Work Order ID 129653

Item ID: D4526-043 Accept ***N900040100*** Setup Start ***NS1***
 Revision ID: Stop ***NS2***
 Item Name: Tube Assembly
 Start Date: 2/23/15 Start Qty: 3.00 ***3*** Cust Item ID:
 Required Date: 2/23/15 Req'd Qty: 3.00 ***3*** Customer:
 Reference:

A		NEW ISSUE		RF	11.11.22
REV.	DESCRIPTION			BY	DATE
DESIGN	RF	DART AEROSPACE USA, INC.			
DRAWN	RF	KENT, WA			
CHECKED	RF	DRAWING NO.	REV. A		
MFG. APPR.	RF	D4526	SHEET 1 OF 5		
APPROVED	RF	TITLE	SCALE		
DE APPR.	RF	MAINTENANCE STEP ASS'Y		NTS	
DATE	11.11.22	COPYRIGHT © 2011 BY DART AEROSPACE USA, INC. THIS DOCUMENT IS PRIVATE AND CONFIDENTIAL AND IS SUPPLIED ON THE EXPRESS CONDITION THAT IT IS NOT TO BE USED FOR ANY PURPOSE OR COPIED OR COMMUNICATED TO ANY OTHER PERSON WITHOUT WRITTEN PERMISSION FROM DART AEROSPACE USA, INC.

From: Jean-Luc Menard
Sent: July-14-14 1:13 PM
To: 'Patrick Smith'; Eric Downing
Cc: Roberto Fuentes
Subject: FW: holes diameter missing on the D4526 sheet 4

D4526-1 TUBING

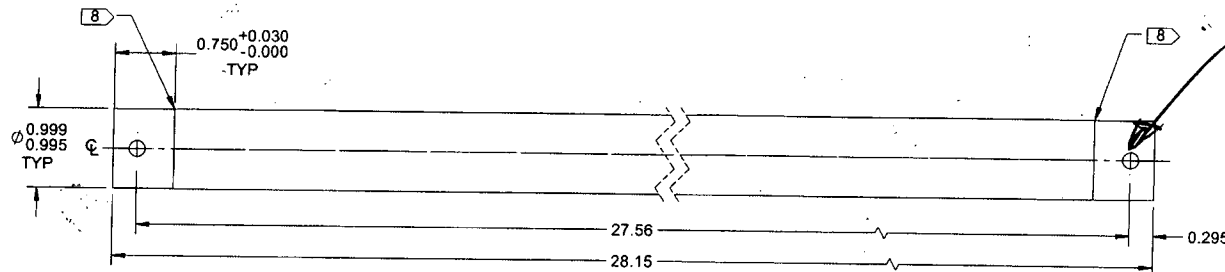
Hi Guys,
Can we open a Par FOR THIS PLS.
THX
JL

From: Roberto Fuentes
Sent: July-14-14 1:12 PM
To: Jean-Luc Menard; Harvey Siemens
Subject: holes diameter missing on the D4526 sheet 4

In respond to your Skype message regarding holes diameter missing on the D4526 sheet 4. The holes are 0.201 in diameter according to the SW file, which is acceptable for a 10-32 screw.
